Product Change Notice (PCN)

PCN Number: **PCN-0210063R-01**

Product(s) Affected: SMRT-3-B

Previous Part Detail	New Part Detail

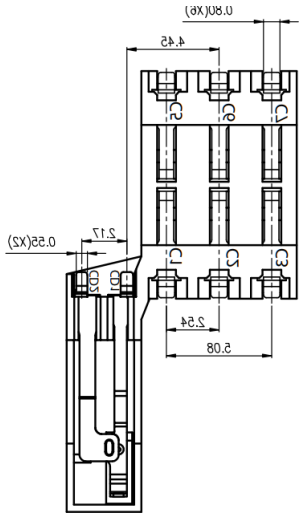
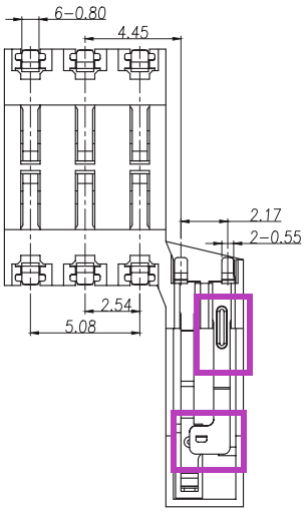
1) Mechanical re-enforcement rib added to the static contact arm.
2) Stamping indent change
